SUNDRY NOTICES AND REPORTS ON WELLS (DO NOT USE THIS FORM FOR PROPOSALS TO DRILL OR TO DEEPEN OR PLUG BACK TO A DIFFERENT RESERVOIR. USE "APPLICATION FOR PERMIT" (FORM C-101) FOR SUCH PROPOSALS.)		WELL API NO. 30-015-54641

2. Name of Operator Mewbourne Oil Company		6. State Oil & Gas Lease No.
3. Address of Operator PO Box 5270, Hobbs, NM 88241		7. Lease Name or Unit Agreement Name Sandlot 9/8 Fee

Mewbourne Oil Company requests that the following changes be made to the Sandlot 9/8 Fee #521H Well (API #30-015-54641):

SANDLOT 9/8 FEE #521H

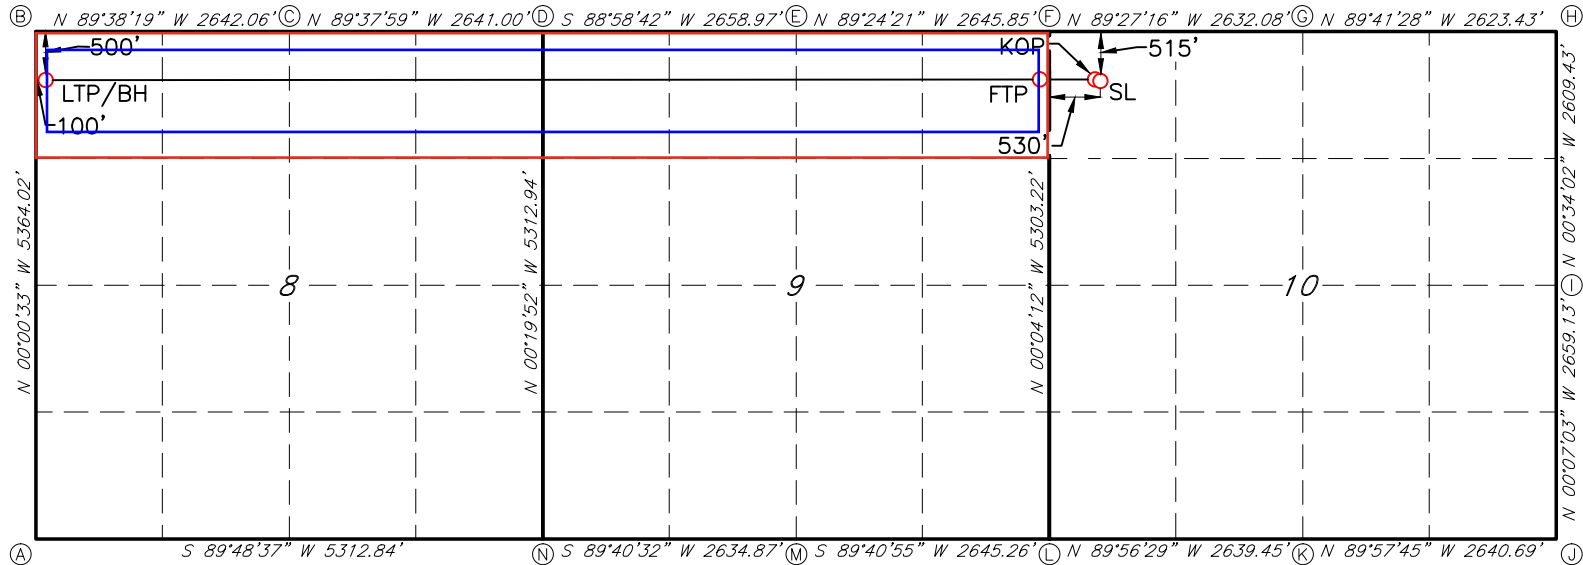
1. Change SHL f/ 255 FNL & 760 FWL (10) to 515 FNL & 530 FWL (10)
2. Change BHL f/ 660 FNL & 100 FWL (8) to 500 FNL & 100 FWL (8)
3. Attached New C102 reflecting these changes.

SURFACE LOCATION (SL)
515' FNL & 530' FWL (SEC.10)
N: 514124.6 - E: 587362.8

LAST TAKE POINT/BOTTOM HOLE (LTP/BH)
500' FNL & 100' FWL (SEC.8)
N: 514157.7 - E: 576348.7
